Figure 3.2.1_Example of signage Type A1 & B

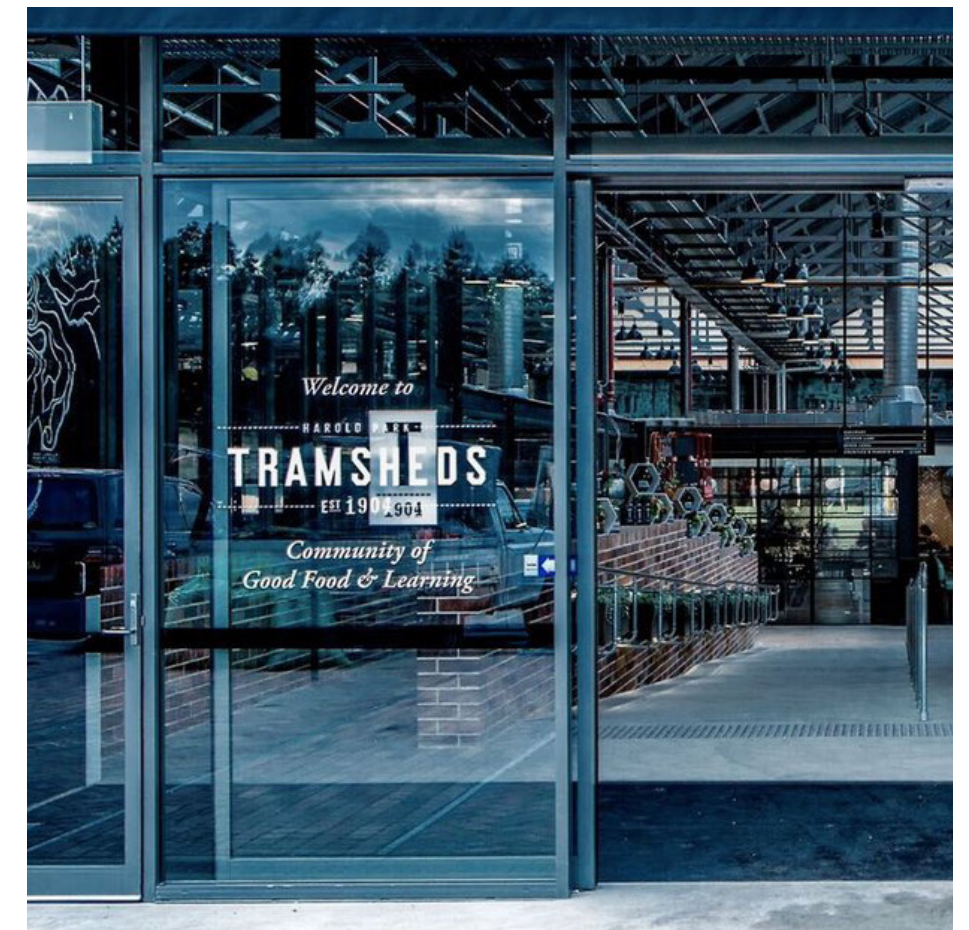
Provide the dimensions of the proposed signage zones, including confirmation of whether future signs will be illuminated. In addition, confirm what is the proposed difference between signage 'type A' and 'type B'.

Signage Type A1: Market Hall Entry Signage (illuminated)

Signage zone above the awning. Maximum size 5,000mm(W) x 750mm(H). For an example Refer to Figure 3.2.1

Signage Type B: Lobby Entry Signage (illuminated)

Signage zone above/below or on the awning. Maximum size 4,000mm(W) x 750mm(H) For an example Refer to Figure 3.2.1

Figure 3.3.1_Proposed Ground Floor Plan - awnings above highlighted in red

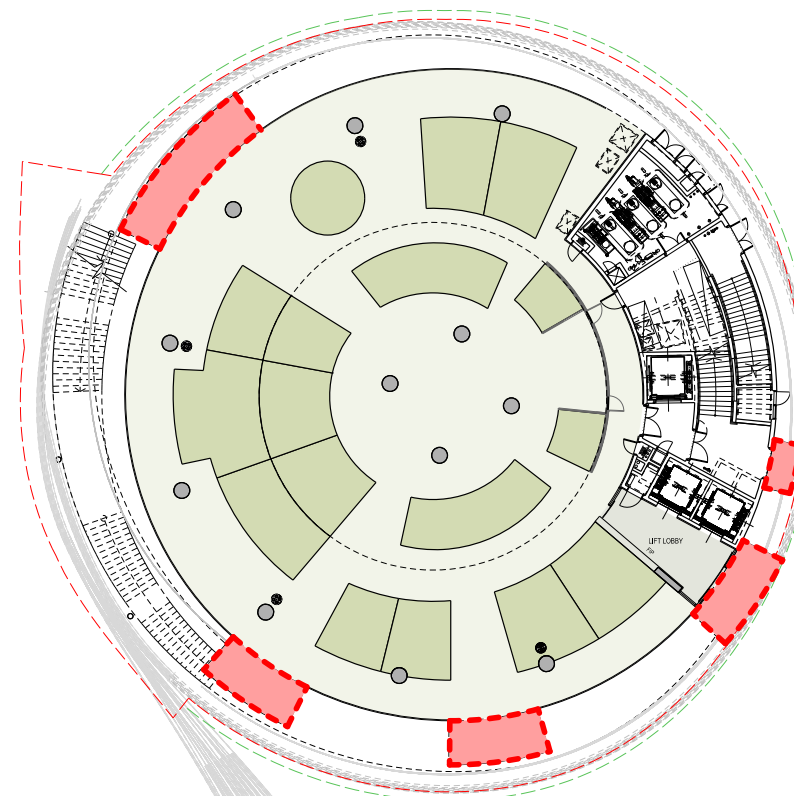
Suggest additional mitigation measures to improve the wind environment around the North Plot.

The City requests that the Applicant confirm whether the findings and recommendations of the wind assessments for the North Plot and South-East Plot are capable of being incorporated. Significant wind effects are predicted at the outdoor space in the North Plot building. In the case of the North Plot, the wind assessment recommends enclosing the affected outdoor space.

A number of awnings have been incorporated above the ground floor entries to provide greater public amenity in the form wind and rain protection. These awnings not only assist with reducing the impact of wind and rain but also provide greater identification of entry points.

1. Ground floor: 5 awnings have been located at each key entry / egress points. Awnings are designed as cantilevered metal elements in a charcoal colour which provides a subtle addition to the building. Refer to Figures 3.3.1 and 3.3.3.
2. Level 5: The Level 5 awning has been updated to provide weather protection and also assist with the wind conditions on the external terrace. The awning (timber, glass and steel) plays an important role in the overall architectural expression of the building. It will read as an extension of the timber facade wrap, seamlessly transitioning from a facade element into the Level 5 awning.
